Item Name: 19.5x8.25

jantsa
Wheel Industry & Trade Inc.Co.
Phone : 0 256 259 11 25
Fax : 0 256 259 11 24
AYDIN / TURKEY

DRAWING NO: 825142

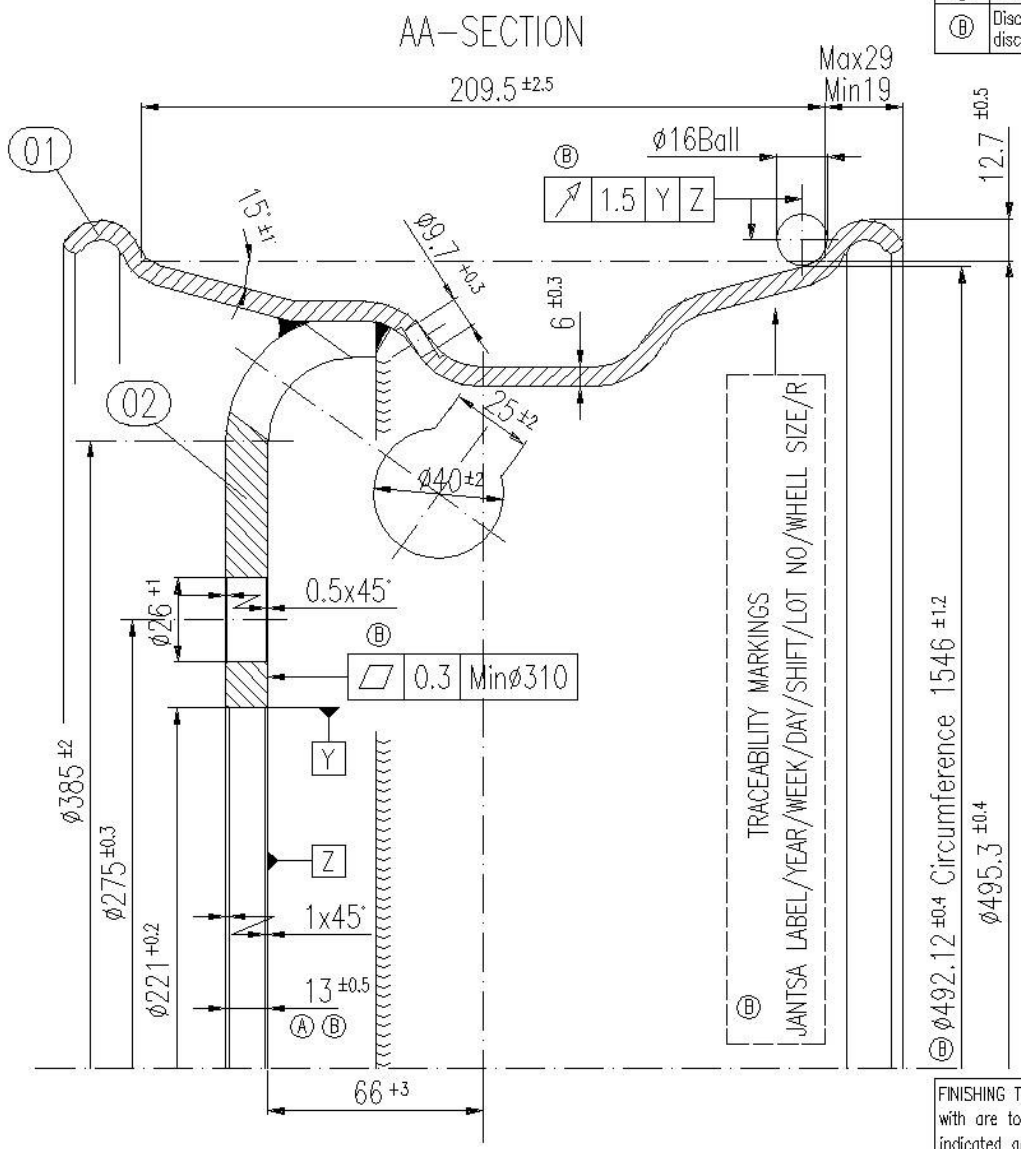
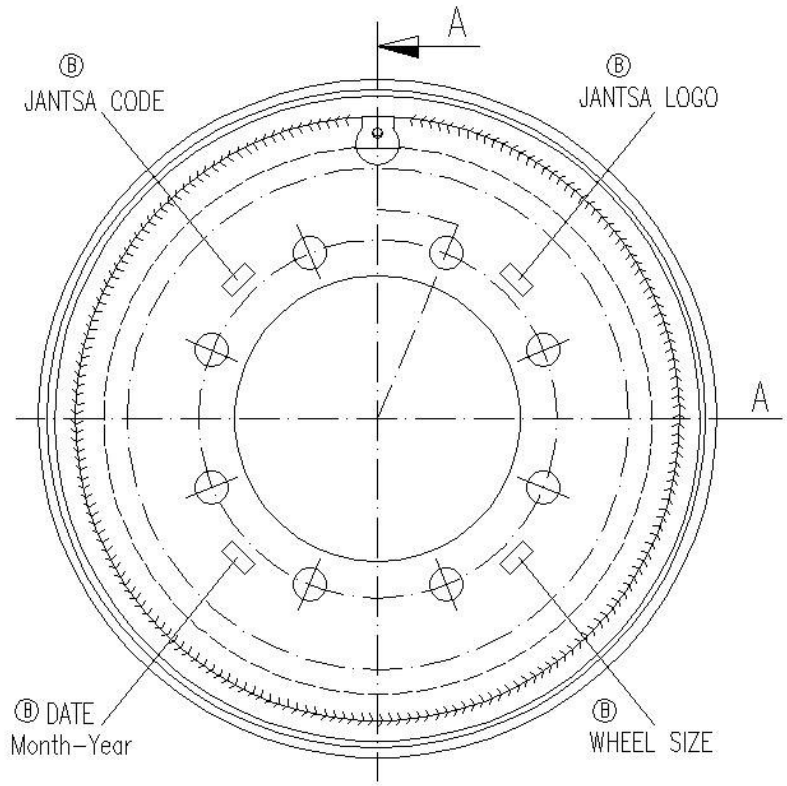
LETTER	DESCRIPTION	REVISION	DATE	REV.NO
Ⓐ	Before 10 mm Now 12 mm.	Disc thickness is changed.	06.06.01	1
Ⓑ	Disc thickness changed. Before 12 Now 13 mm. Load capacity and disc, rim markings added.	Drawing is revised.	08.12.06	2

Ⓑ Load capacity 3350 Kg at 100 Km/h.
